## **REPORT**

### **2<sup>nd</sup> meeting of GRRF Informal Working Group on Automatically Commanded Steering Function**

Venue: Jasic Office Tokyo, Japan.  
Chairman: Mr. Christian Theis (D) and Mr. Hidenobu Kubota (J)  
Secretariat: Mr. Jochen Schaefer (CLEPA)  
Dates: 16.-17. June 2015  
Website: <https://www2.unece.org/wiki/display/trans/ACSF+2nd+session>

## 5. Attention recognition (2.4.8.13)

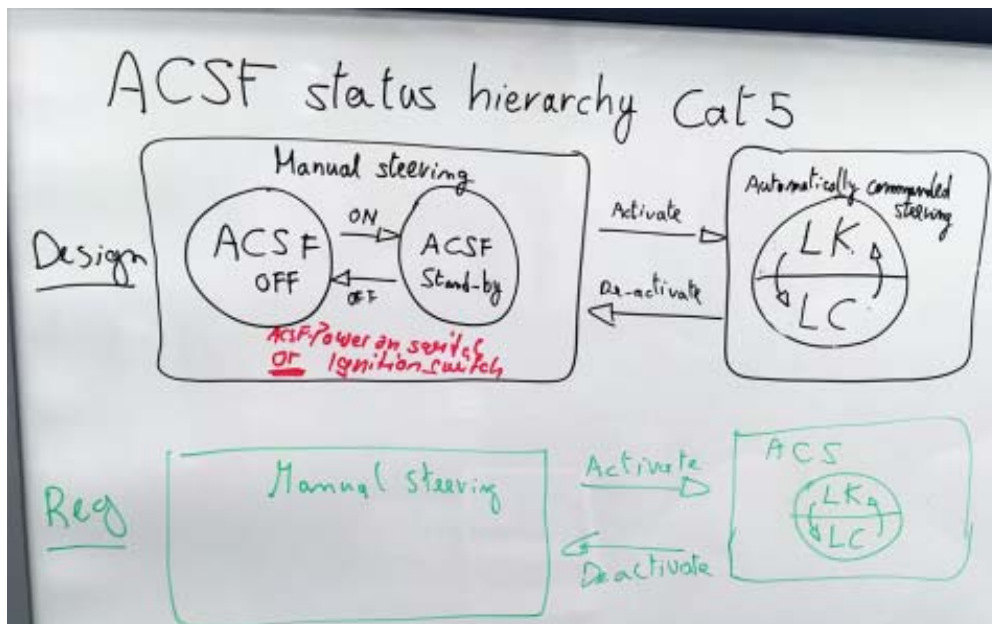
OICA: Attention of the driver cannot be detected.

Only “secondary criteria” e.g. closed eyes, looking to the side, can be detected
